NINE MILE POINT NUCLEAR STATION, UNIT NO. 1

AMENDMENT TO FACILITY OPERATING LICENSE

Amendment No. 68
License No. DPR-63

SAFETY EVALUATION BY THE OFFICE OF NUCLEAR REACTOR REGULATION

FIGURE 6.2-1
NINE MILE POINT NUCLEAR STATION
MANAGEMENT ORGANIZATION CHART

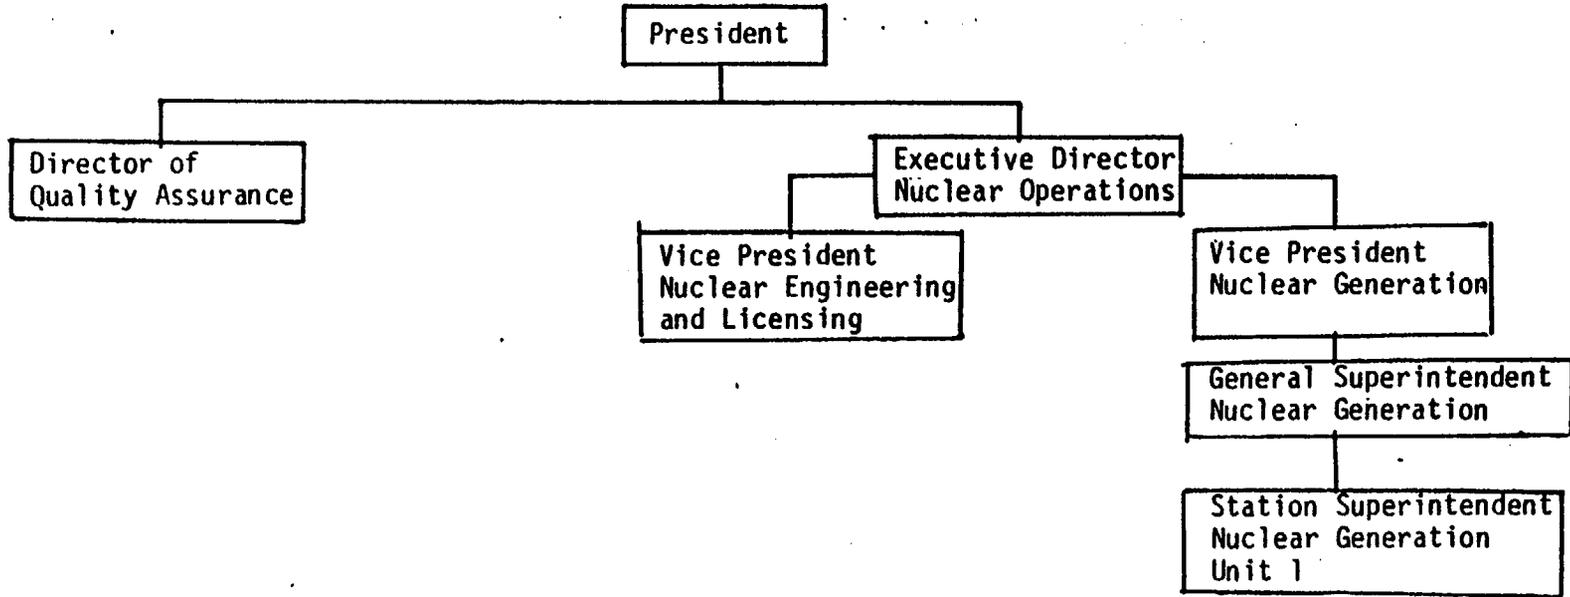
By application dated July 19, 1984, Niagara Mohawk Power Corporation (the licensee) requested an amendment to Appendix A of Facility Operating License No. DPR-63 for Nine Mile Point Nuclear Power Station, Unit No. 1. The licensee requested that Technical Specification Figure 6.2-1 be changed to reflect a revised arrangement of certain upper management positions in the corporate organization.

Although the requested change to Figure 6.2-1 is manifested only in two position title changes, the major consideration centers on the fact that these two positions are filled by individuals who are employees of a consulting firm, not of Niagara Mohawk Power Corporation (NMPC), the licensee.

In order to utilize the skill and knowledge of these individuals to enhance the management capability and at the same time maintain all authority and responsibility for nuclear construction and operations within the Corporation's management structure, the Board of Directors of Niagara Mohawk Power Corporation has created the positions of Executive Director of Nuclear Operations and Director of Quality Assurance and has designated Mr. B. G. Hooten as Executive Director of Nuclear Operations and Mr. J. A. Perry as Director of Quality Assurance for Niagara Mohawk. As Executive Director of Nuclear Operations, Mr. Hooten assumes the functions formerly performed by the Senior Vice President, Nuclear Operations. Mr. Perry, as Director of Quality Assurance, assumes the functions performed by the Vice President of Quality Assurance.

As a result of the delegation of authority and responsibility by the Board of Directors, the position of Executive Director of Nuclear Operations and Director of Quality Assurance possess the essential attributes of their antecedent offices and possess the authority of officers of the Corporation.

Based upon the licensee's statements to the effect that the two individuals involved will have the authority of officers of the Corporation, the staff concludes that there has been no substantive negative change to the organization and, therefore, the proposed change to Technical Specification Figure 6.2-1 is acceptable.
